Building Manager: [Tarrigon Van Denburg, vandenbt@oregonstate.edu](mailto:Tarrigon.Van.Denburg,vandenbt@oregonstate.edu)
 Assessment Date: 9/21/2022
 Assessment Number: **10607**
 Location: Batcheller Hall Entire
 Reinspection date:

A joint fire safety inspection of the facility listed above was performed by the Environmental Health & Safety - Fire and Life Safety and the Corvallis Fire Department. These fire safety deficiencies could result in a fire or jeopardize the safety of those occupying the facility. Please see that these items are corrected immediately and no later than the scheduled reinspection date noted with this report. If you have any questions regarding this inspection, please email Brian Lilley (EH&S - Fire and Life Safety) at brian.lilley@oregonstate.edu.

Room 045

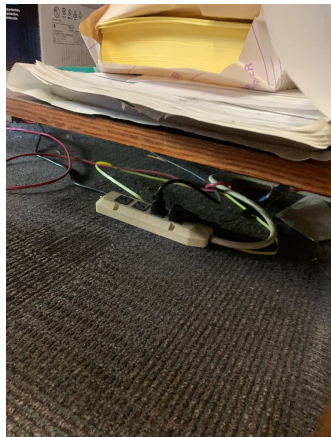
3	Required fire walls, occupancy separation walls, and draft stops shall be maintained.	2019 OFC 703.1	0045:ceiling	FS	Repair/replace ceiling tiles in room 045.	
---	---	----------------	--------------	----	---	--
